STAFF COMMENTS

PLANNING BOARD MEETING

June 14, 2017

Case # 25-17: Audrey Rose Farms
Definitive Subdivision
off Lantern Lane
(Map 80, Lots 140 & 141)

SHEET 1 OF 7

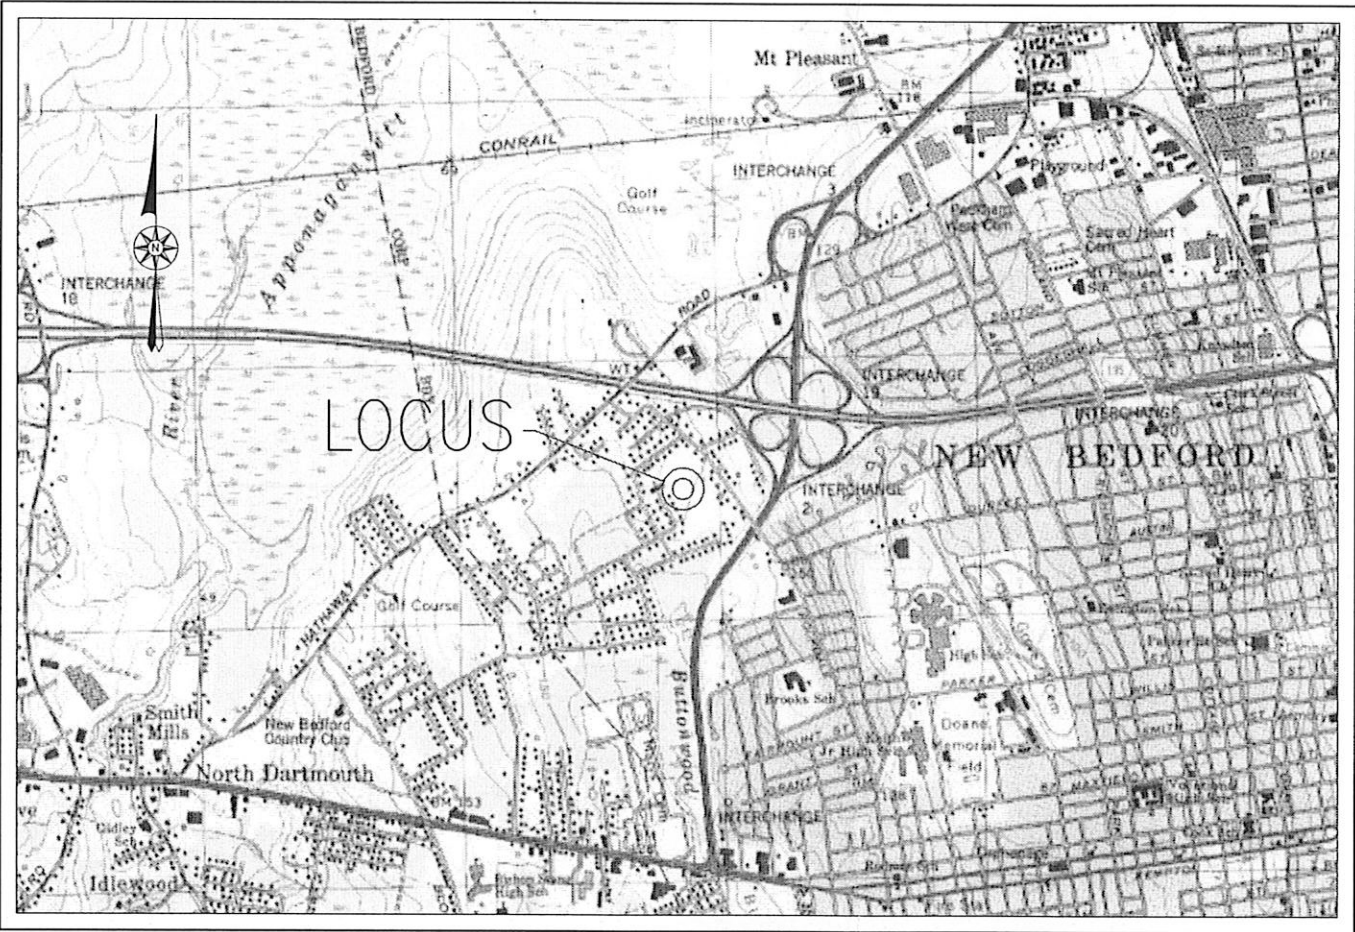
- ☐ The Zoning Matrix should state the percentage of contiguous uplands per each lot as being greater than 83% and also provide the total square footage of upland per lot.
- ☐ Correct the following typo under Deed References on this plan sheet and other sheets as shown:
 - Book 3612, Page 12 (This appears to run with the mortgage deed for a property at the neighboring subdivision called Sandstone Heights).
- ☐ Correct the following under Plan References:
 - PB 70, is found on Page 40, not Page 10;
 - PB 114, Page 12 is for a Plan of Land for Chase Road in South Dartmouth;
 - Add Plan Book 170, Page 82;
 - Include other associated plans on the Cover sheet.

SHEET 3 OF 7

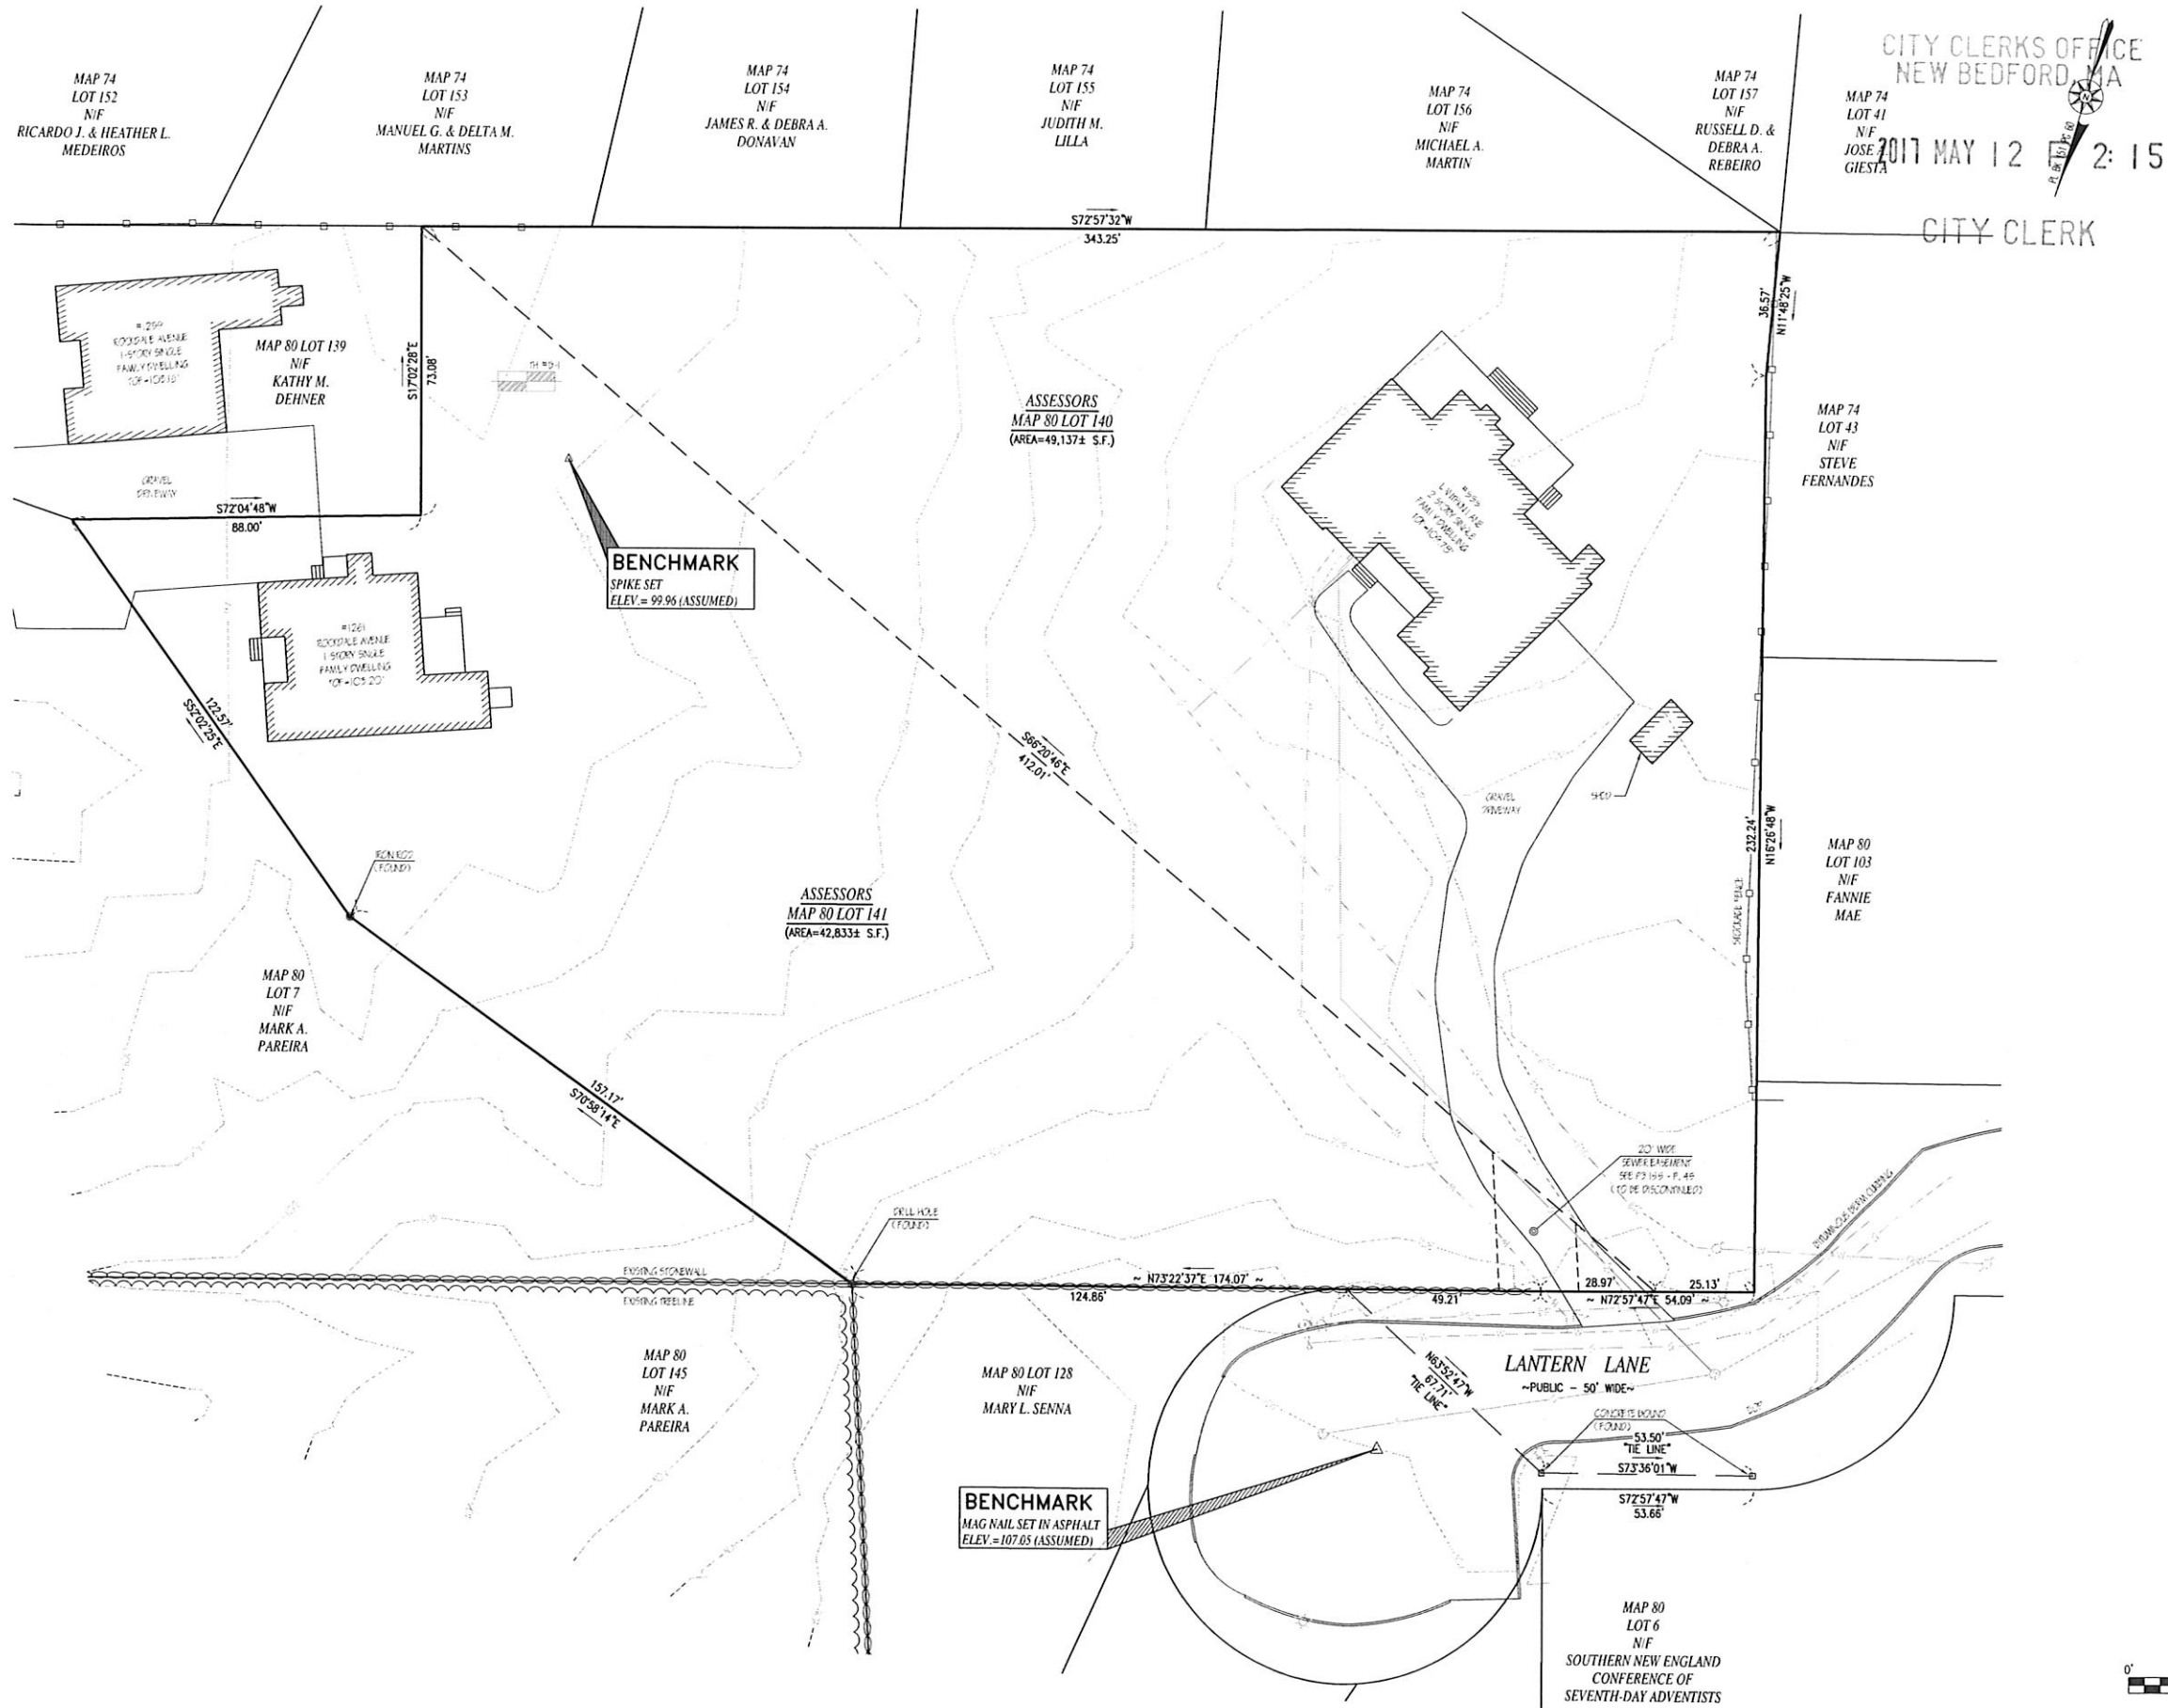
- ☐ Show the building envelope and setbacks.
- ☐ Note the percentage number in the calculation of contiguous uplands [i.e., Lot 14: 31,748 +/-SF (26, 351 +/- Upland) = 83% contiguous upland].
- ☐ Parks and Playground have not been shown on plans as per **Article V. General Requirements for the Subdivision of Land (18)** and **MGL Chapter 41 §81U**.
- ☐ Note utility easement deed book and page number(s) to final plan upon recording at the Bristol County (S.D) Registry of Deeds.
- ☐ Assure that the owner of Map 80, Lot 103 is consistent on all plan sheets.
- ☐ Add **General Construction Notes** from plan sheet 7 of 7.

- ☐ Add all Construction Notes as stipulated in under Section 3d. of the Site Plan Review Checklist:
 - Any minor modifications to the information shown on the approved plans shall be submitted to the City Planner and City Engineer as a Minor Plan Revision for approval prior to the work being performed.

- All pavement markings and signs shall conform to MUTCD requirements.
- ☐ The applicant/owner shall be responsible for removal and garbage pickup under **Article V. General Requirements for the Subdivision of Land (24)**; add this to Notes on plan sheet.

5
5 ROADWAY CROSS SECTION
NOT TO SCALE

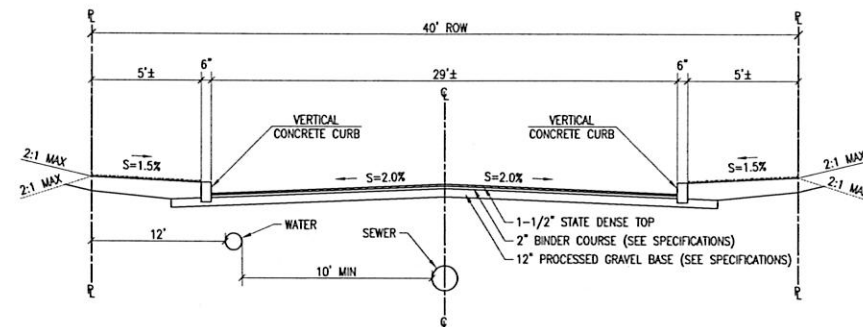
- ☐ Add tree planting Note to Landscape Plan
- ☐ Add roadway cross section and driveway curb cut Note to Roadway Profile Plan Sheet
